# UNITED STATES PATENT AND TRADEMARK OFFICE

APPLICATION NO.	FILING DATE	FIRST NAMED INVENTOR	ATTORNEY DOCKET NO.	CONFIRMATION NO.
10/523,950	10/19/2005	Ian James Prismall	ARD120USA	9425
24339 7590 06/25/2008				
JOEL D. SKINNER, JR. SKINNER AND ASSOCIATES 212 COMMERCIAL ST. HUDSON, WI 54016				
EXAMINER				
AMIRI, NAHID				
ART UNIT		PAPER NUMBER		
3679				
MAIL DATE		DELIVERY MODE		
06/25/2008		PAPER

### Office Action Summary

## DETAILED ACTION

Fig. 1

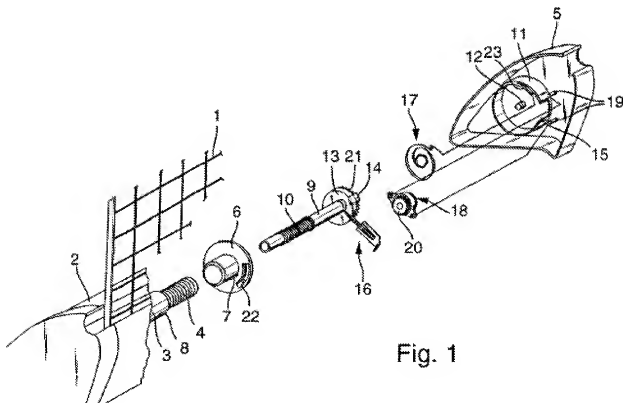
**Claims 1, 5-8, and 13 are rejected under 35 U.S.C. 102(b) as being anticipated by US Patent No. 6,715,525 Ehrenberger et al.**

With respect to claims 1, 5-8, and 13, Ehrenberger et al. disclose a retractable barrier system (16, Fig. 1) comprising a support member (7), a spool (3) supported for rotation by the

support member (7), a spring (4) arranged to provide a biasing load to the spool (3), and a skirt (2) the spring (4) being located beneath the skirt (4) and the skirt (20) being arranged to deflect water away from the spring (4) which would otherwise impinge on the spring (4); wherein the skirt (2) is carried by the spool (3); having all the components of the barrier system such as the spool (3) and the skirt (2) are interconnected with each other that constitutes unitary with one another; further having a cover (constituted by a bearing sleeve 6), a closed compartment within the spring (4) is housed; wherein the cover (6) is secured to the skirt (2) by at least one a screw thread (10); further having a fixed spindle (9) supported by the support member (7) and upon which the spool (3) is mounted for rotation; wherein the spring (4) includes a first end part anchored to the support member (7) and a second end part is capable of driving the spool (3); and wherein the integrally formed skirt (2) and spool (3) capable of deflecting drain water radially outwardly, around and past the spring (4).
